# Service Manual

*Supplement*

**KX-TS2388CAB/KX-TS2388CAW/  
KX-TS2388RUB/KX-TS2388RUW/  
KX-TS2388UAB/KX-TS2388UAW/  
KX-TS880B/KX-TS880W/  
KX-TS880LXB/KX-TS880LXW/  
KX-TS880MLW/KX-TS880MXB/  
KX-TS880MXW/KX-TS880NDB/  
KX-TS880NDW/KX-TS880SAW/  
KX-TS881MXB/KX-TS881MXW/  
KX-TS889MXW/KX-TS108W**

Integrated Telephone System

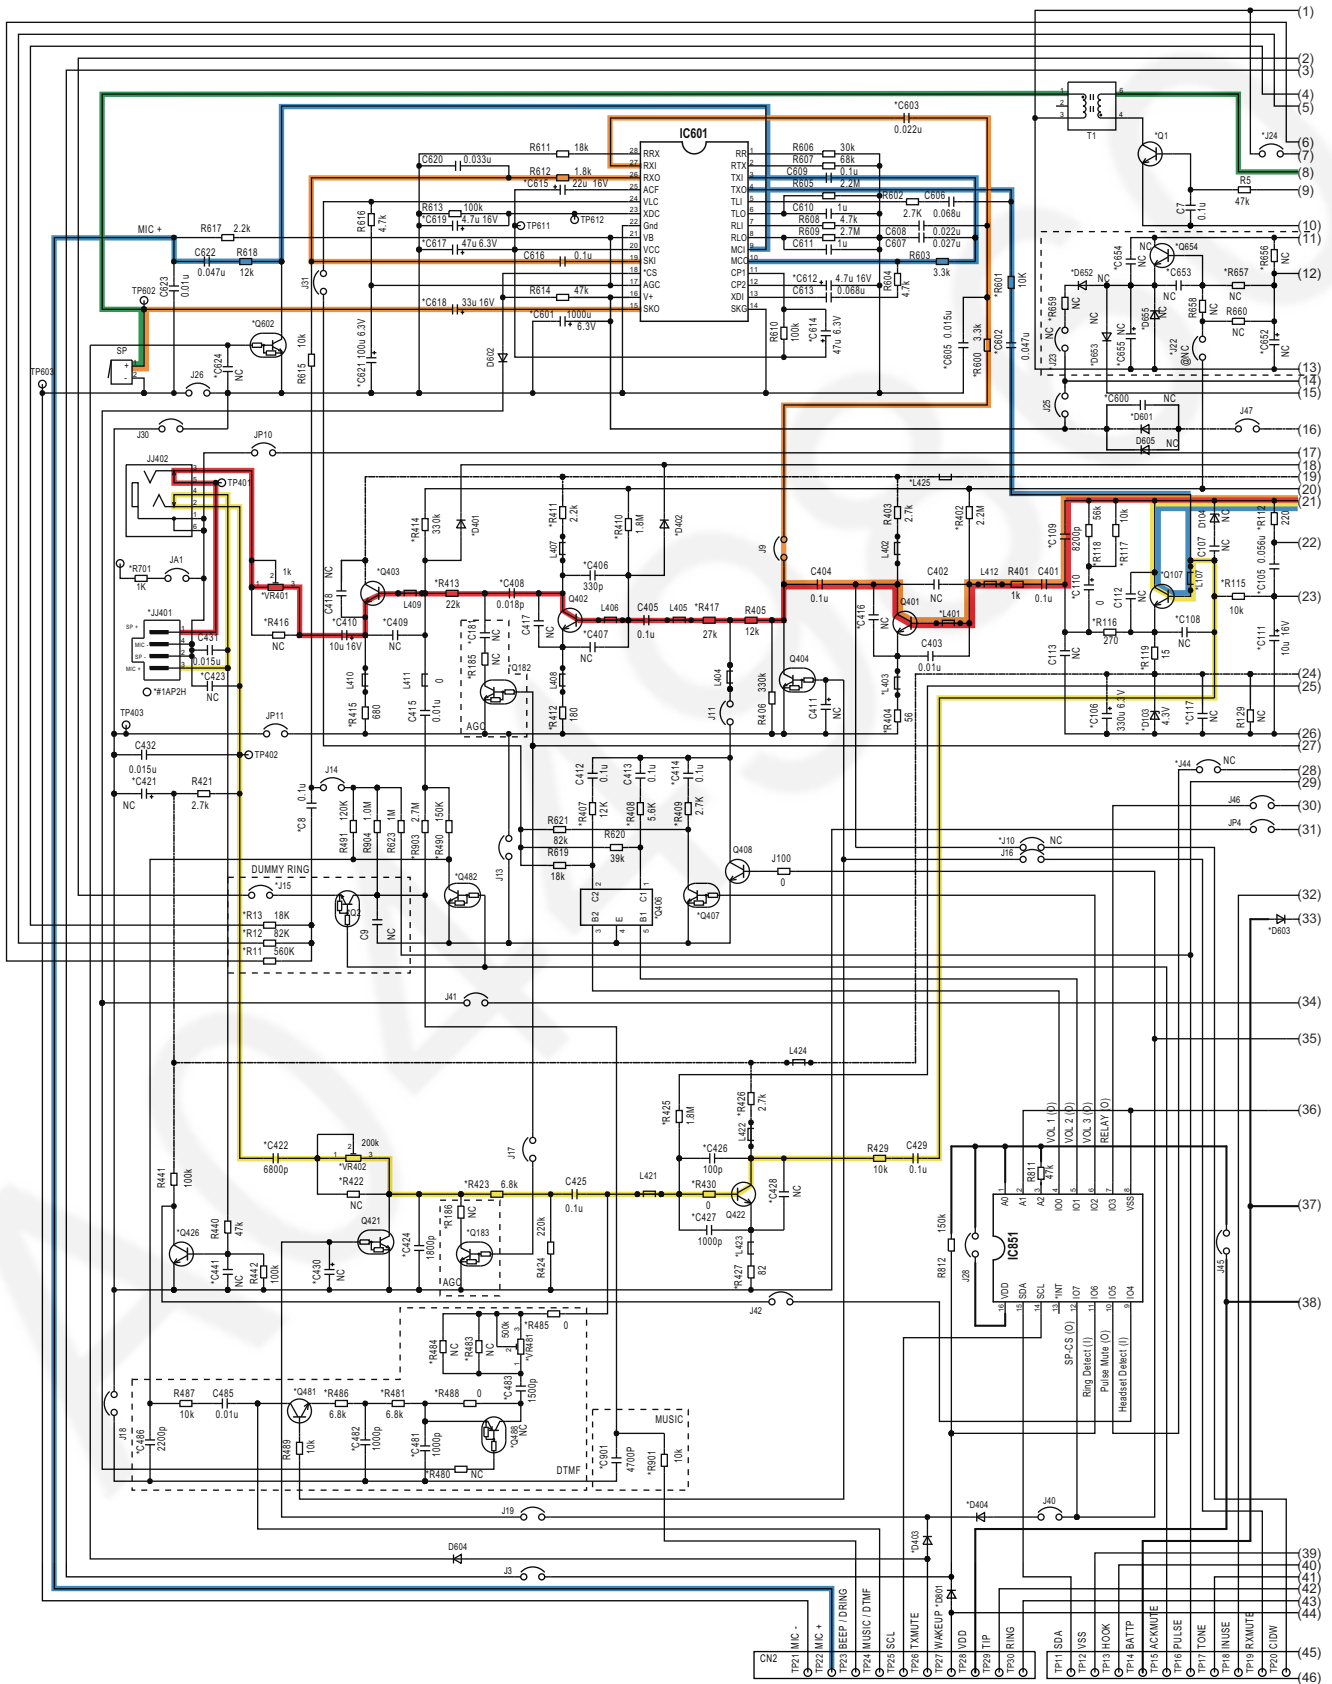
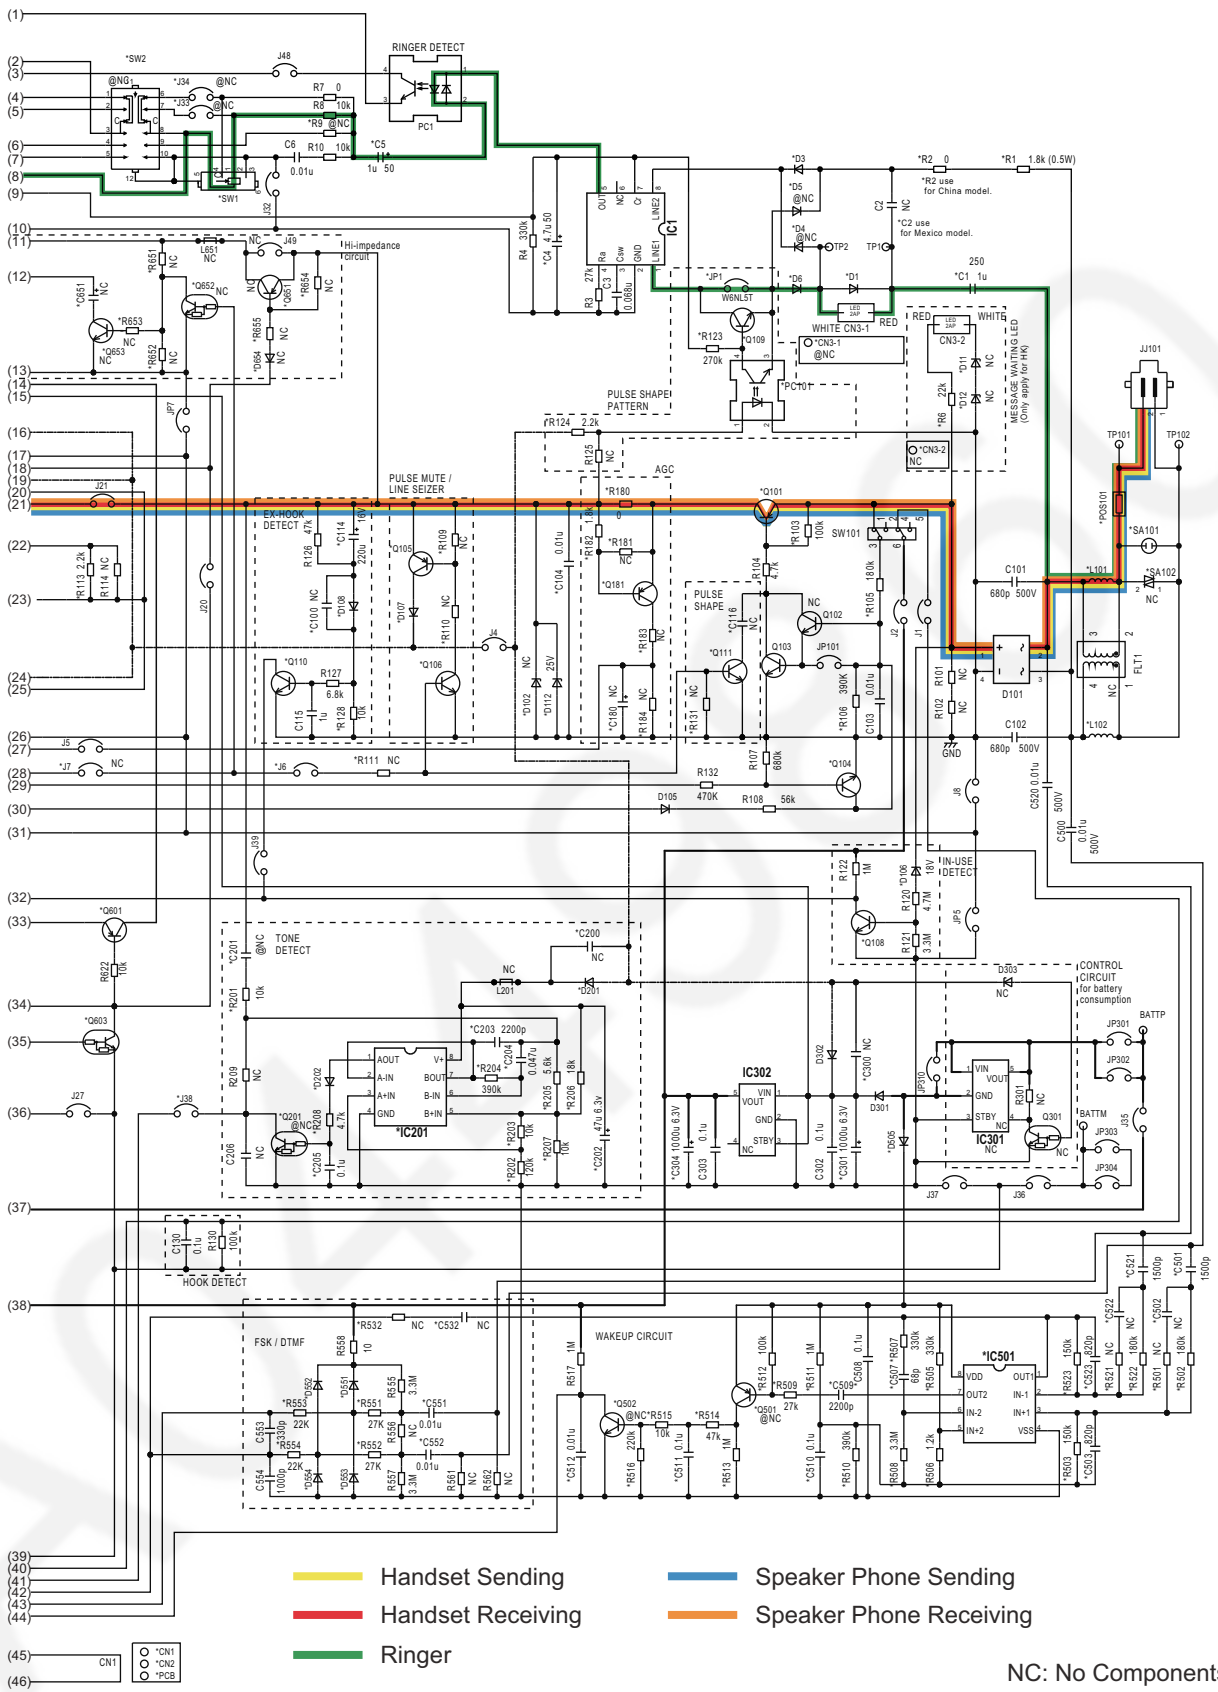
PNLB1814VA PCB has a new diode (chip mount type) at D112 location to replaced an axial diode which previously at D102 location. Old PCB with date code before 2014.07.07, does not have land for D112.

Please refer to **3.1 SCHEMATIC DIAGRAM (FOR P.C.BOARD PART No. PNLB1814VA)** (P.4) and **3.2 CIRCUIT BOARD (FOR P.C.BOARD PART No. PNLB1814VA)** (P.24) for detail.

NC: No Components  
 KX-TS880 SCHEMATIC DIAGRAM (Main)

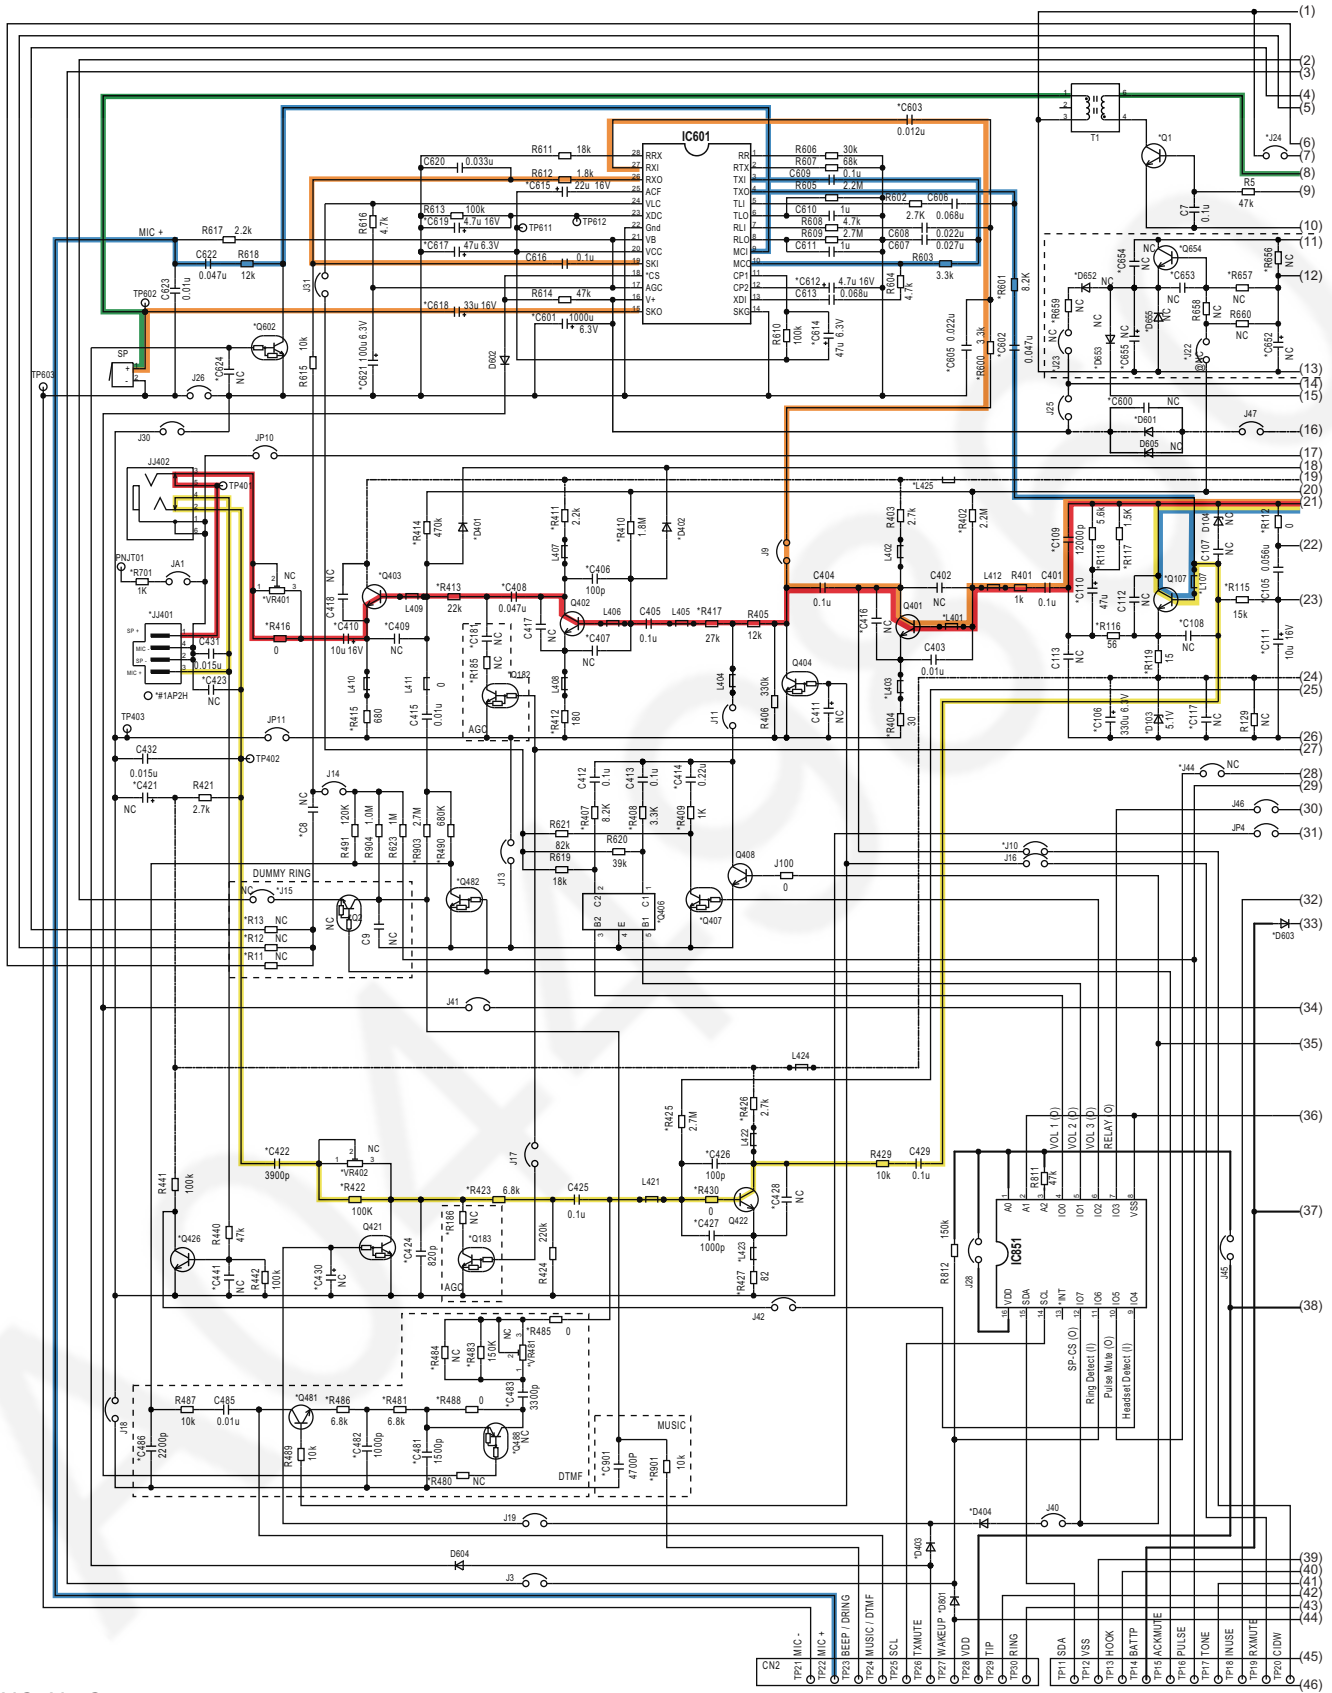
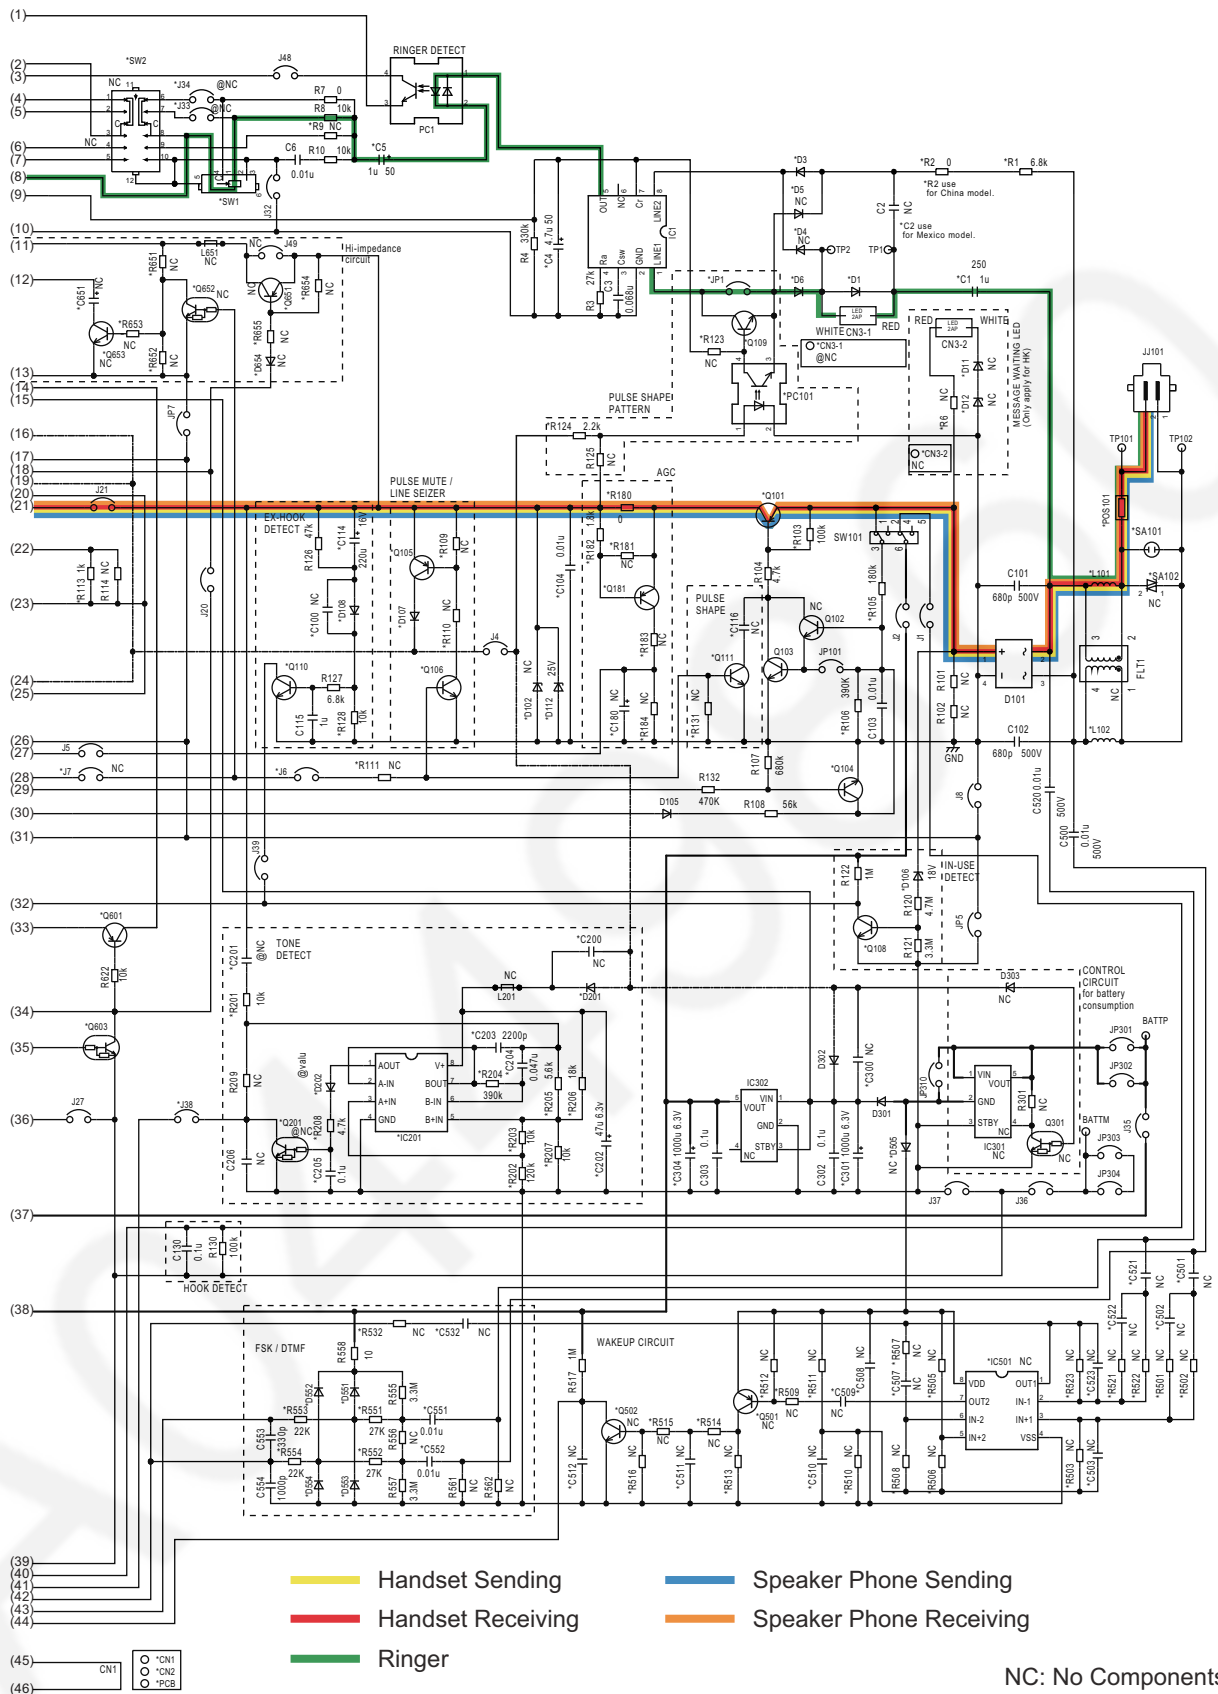
[Changed from original section "7.2. Schematic Diagram (Main)"]
